STATE OF FLORIDA
DIVISION OF ADMINISTRATIVE HEARINGS

APPLICATION FOR POWER PLANT)
FLORIDA POWER & LIGHT)
COMPANY, MANATEE ORIMULSION)
PROJECT, APPLICATION NO. 94-35)

**STIPULATED WITHDRAWAL OF REQUEST FOR HEARING
TO CONTEST CERTAIN SUFFICIENCY COMMENTS**

BOILER CROSS SECTION

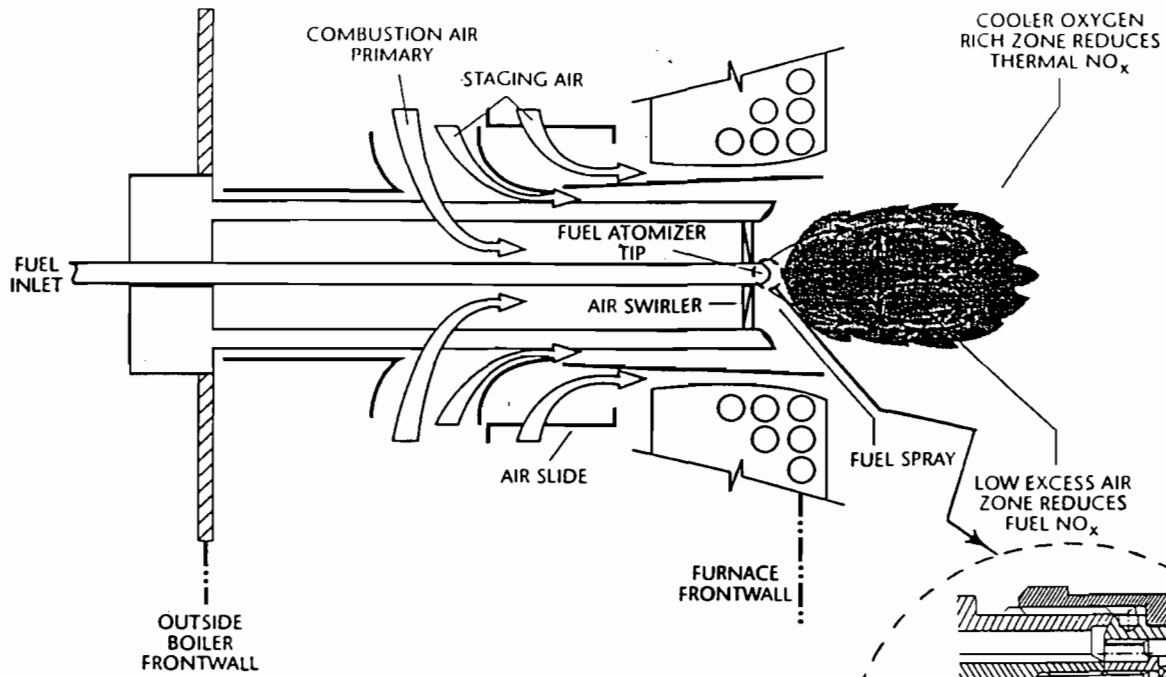
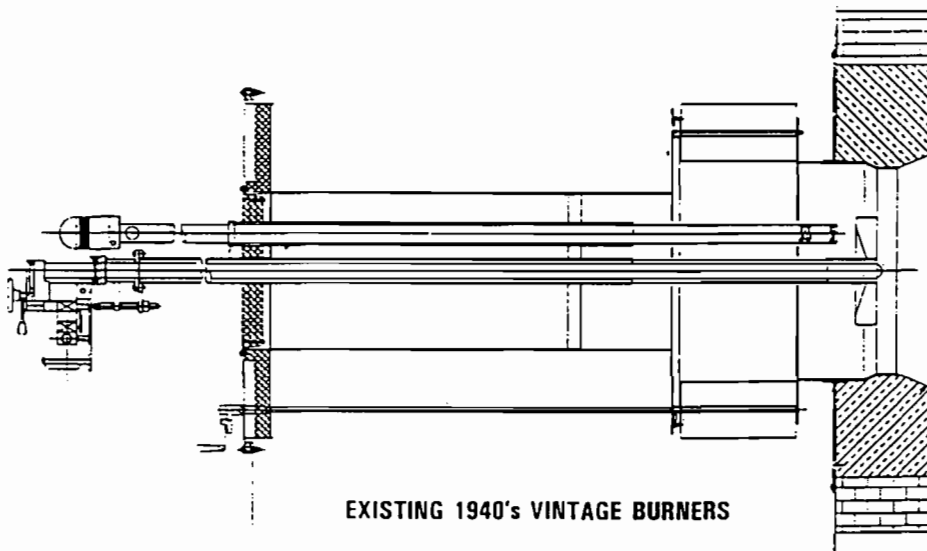
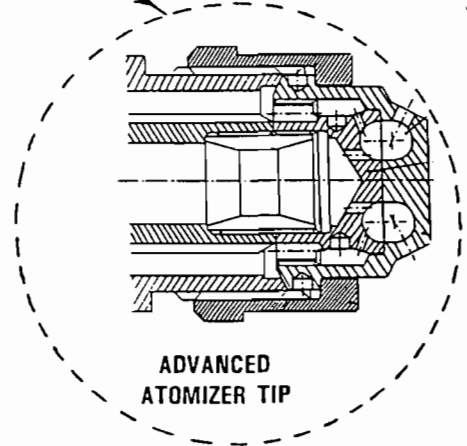
25. Item 1 of the Key to Boiler Alterations in Figure 1 states that the "Boiler is designed for and has provisions to add 2 additional division walls to existing 7 walls". Please give a verbal description of exactly what these provisions consist of.

26. Item 2 of the Key states that the "Boiler is designed for and has provisions to add 10 extra tubes to each of 7 existing division walls". Please give a verbal description of exactly what these provisions consist of. What will be the total number of tubes in each of these 7 existing division walls?

29. Item 3 of the Key states "Upgrade existing primary superheater". Does "upgrade" mean "replace" or "an addition"?

30. Item 5 of the Key states "Upgrade selected non-pressure parts, casing and supports". Does "upgrade" mean "replace" or "additions to"?

31. Item 7 of the Key states "Install additional sootblowers and relocate other (see legend)". The legend icons for existing sootblower locations and new sootblower locations seem to indicate 13 new sootblower locations and 15 existing sootblower locations for a total of 25 sootblowers. Is this correct? Which of the existing sootblower locations shown are in relocated positions?

Comment: Please provide detailed engineering drawings showing proposed equipment modifications (e.g., addition of soot blowers, tube changes, burner nozzle changes, etc.) and any recent modifications (e.g., steam atomization).

Response: Please refer to Figure 1 for conceptual sootblower, tube surface, burner and non-pressure part alterations as well as the recent steam atomization alterations (which were installed for reasons other than Orimulsion). There will likely be some fine tuning of these arrangements during the detailed design phase of the project. Figure DEP-B1-2 shows cross sections of the existing 1940's vintage burners and a typical low NO_x burner featuring staged combustion, with a typical advanced fuel gun atomizing tip (nozzle).

CONCEPTUAL BOILER ALTERATIONS FIGURE NO. 2

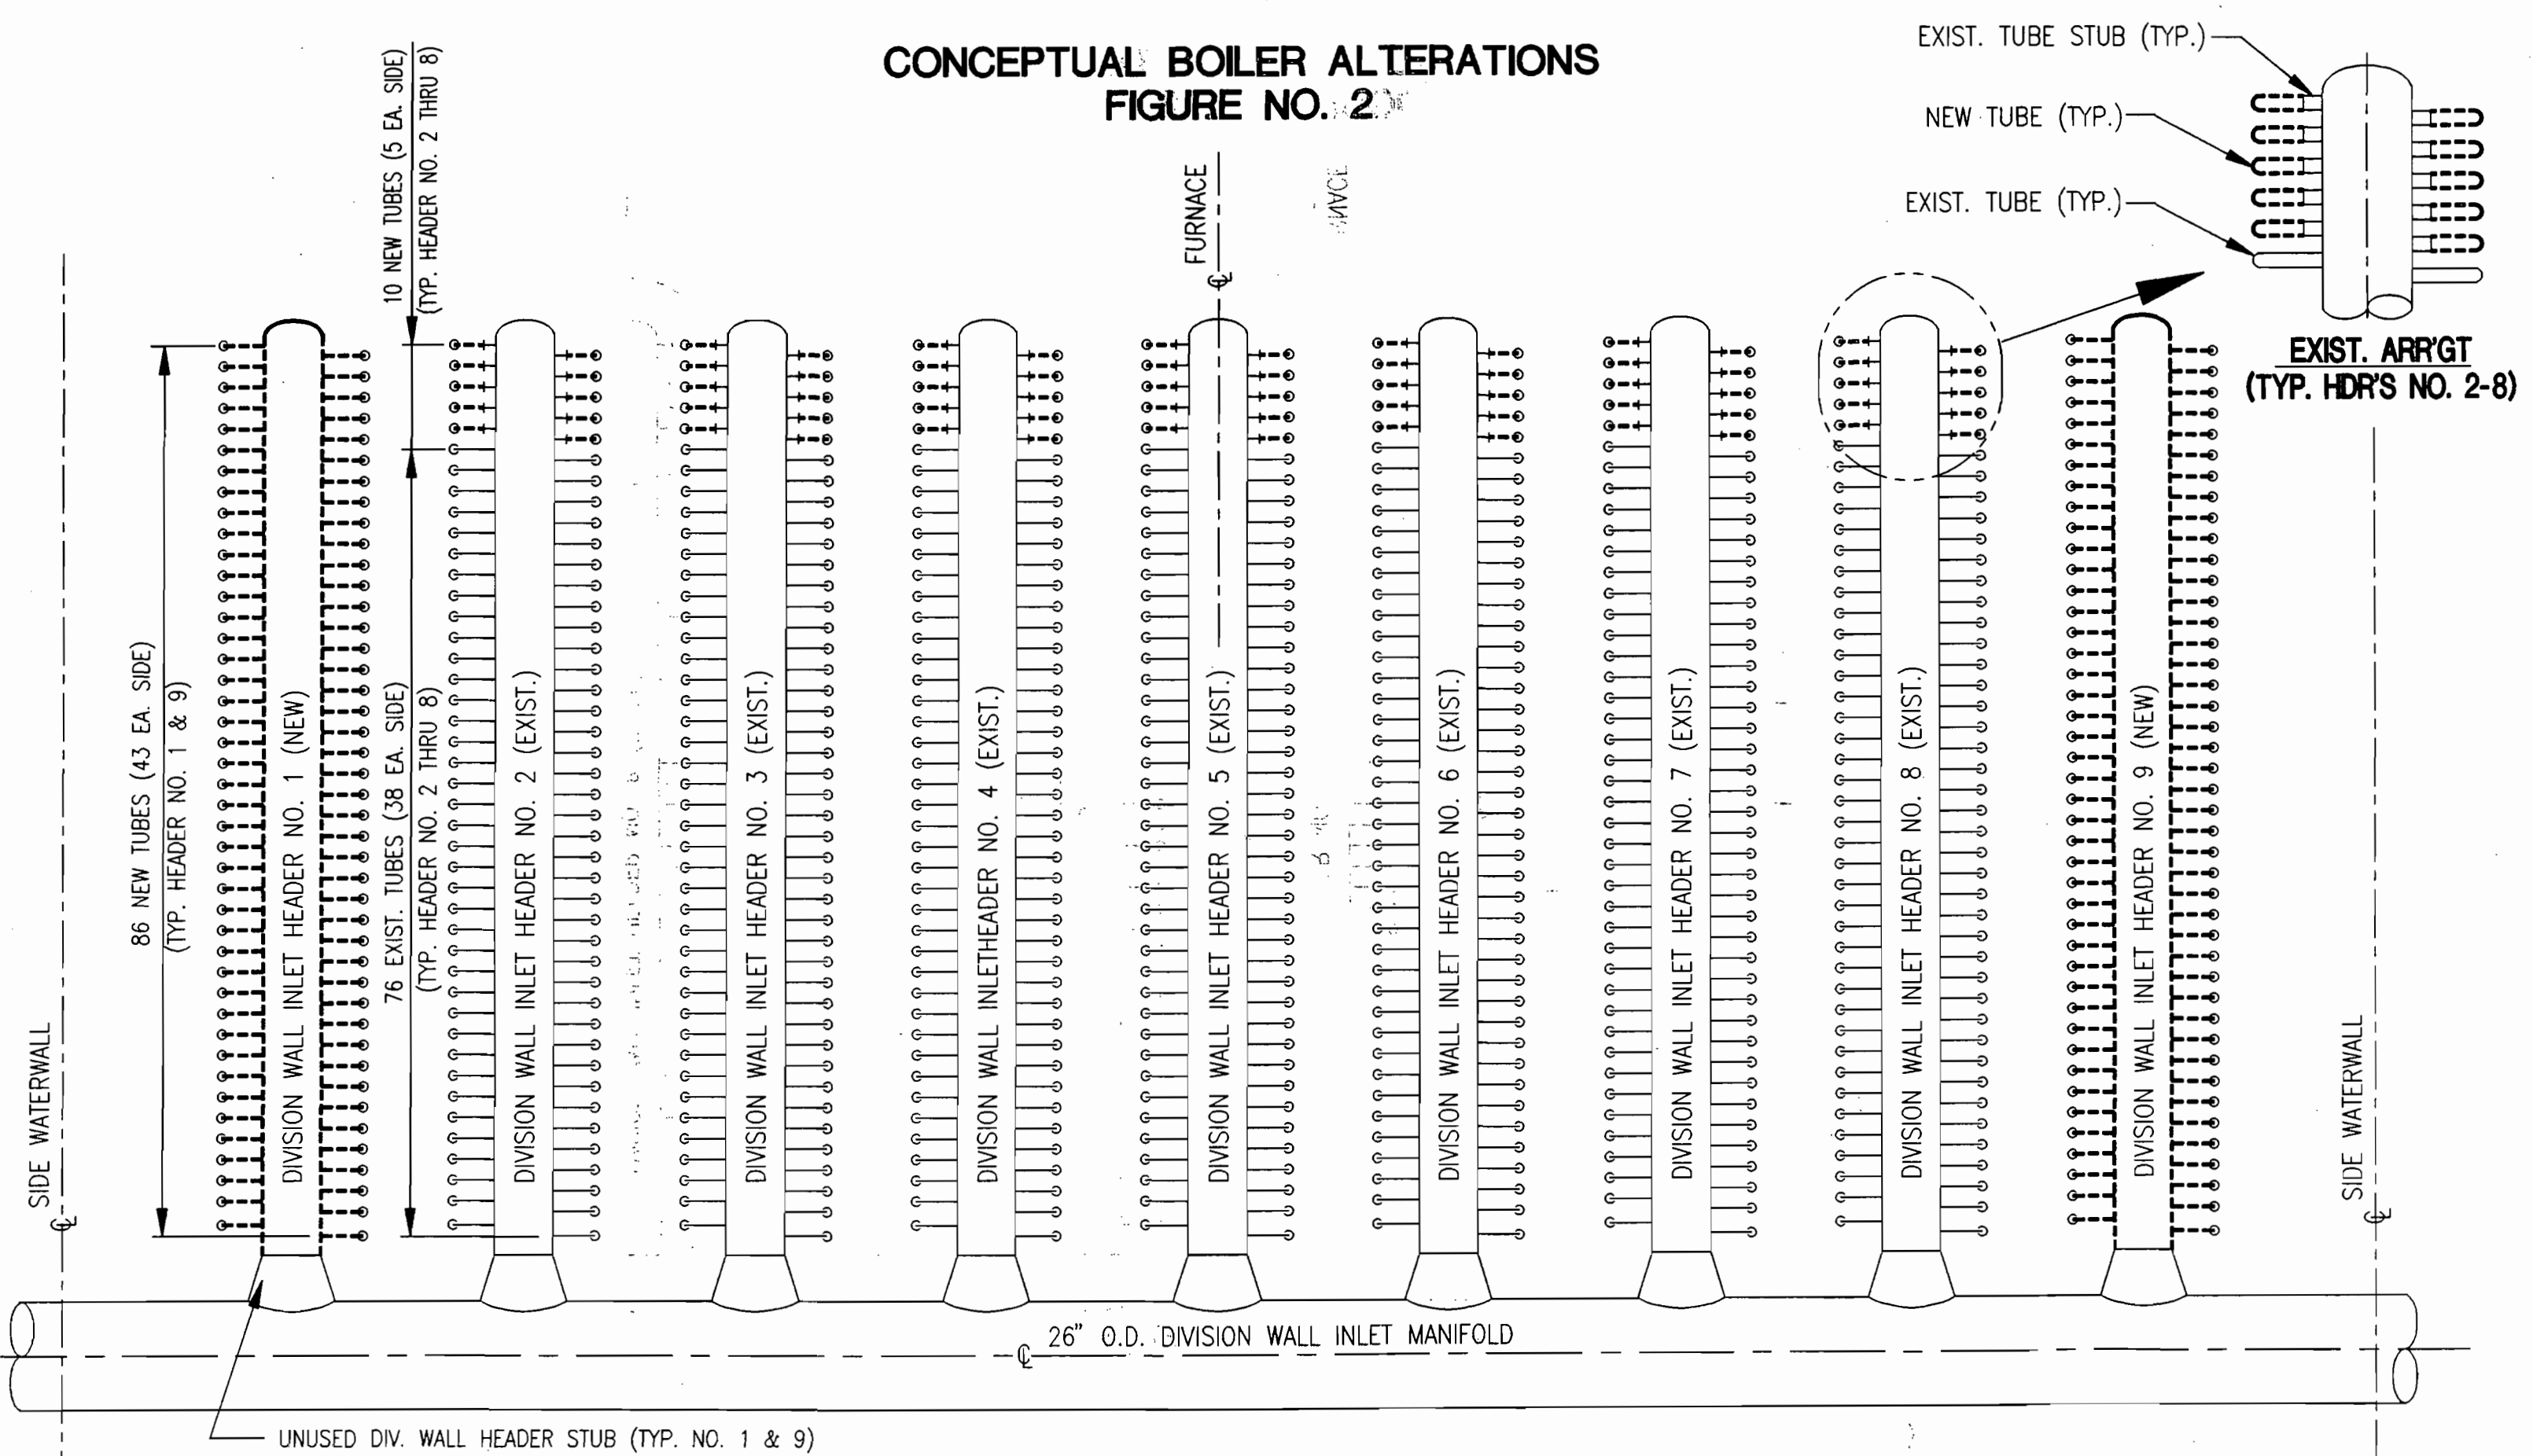
Comment: Item 1 of the Key to Boiler Alterations in Figure 1 states that the "Boiler is designed for and has provisions to add 2 additional division walls to existing 7 walls". Please give a verbal description of exactly what these provisions consist of.

Response: The provisions to add two (2) additional division wall panels to the existing seven (7) panels are depicted in Figure 2 and are described as follows:

Response: Provisions to add ten (10) extra tubes to each of the existing seven (7) division wall are depicted in Figure 2 and are described as follows:

Response: As noted in response to sufficiency comment 2DEP-25 above and depicted in Figure 2, the "new division wall panels will be added at stubs #1 and #9", hence the note "outside panels @ each side only".
